CENTRAL COAST
ENGINEERING

November 12, 1985

RE: Higuera Street Improvement Plans

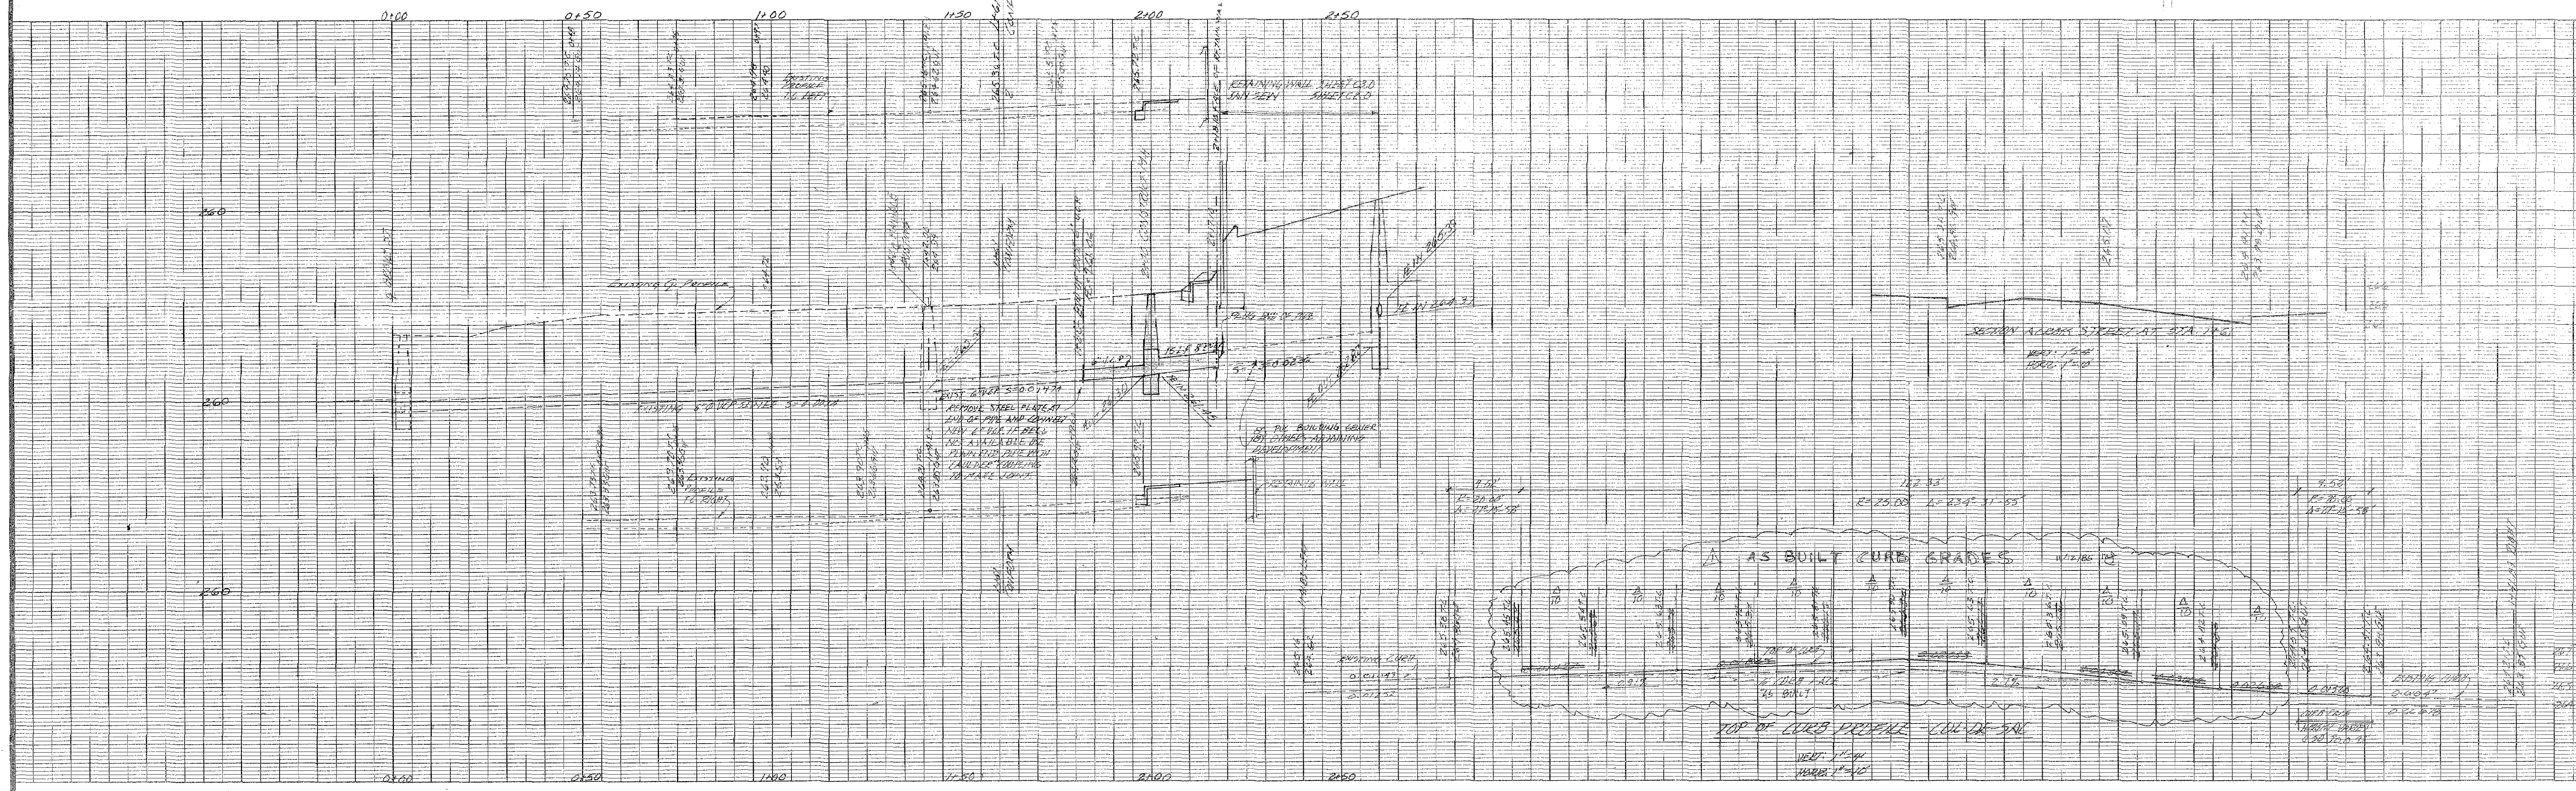
Please find attached copies of the above improvement plans. The plans show changes to the cul-de-sac curb elevations. While the grades differ from those approved, they better fit the existing improvements and should provide a better finished product. The reasons for the change are as follows:

- 1) Once the end of the existing street was excavated, it was found that pavement existed at the cul-de-sac end and that it was approximately 0.5' below design grade. Lowering the high point by 0.44' provided a better fit to the existing pavement while allowing a 0.08' minimum overlay for the final paved surface.
- 2) The back of sidewalk grade for the approved drawing was 0.16' higher than the walkway tie in elevation at the lot on the northwesterly cul-de-sac. The proposed modification places both pavement sections at the same elevation.
- 3) Lowering the cul-de-sac at the Lee property allowed for property drainage to flow across the sidewalk and thereby eliminate a potential ponding problem in the lawn area.

Although the gutter grade at the northwest portion of the cul-de-sac is below 1% (0.91%), there are no anticipated drainage problems. There is little tributary area for this 50' stretch of paving.
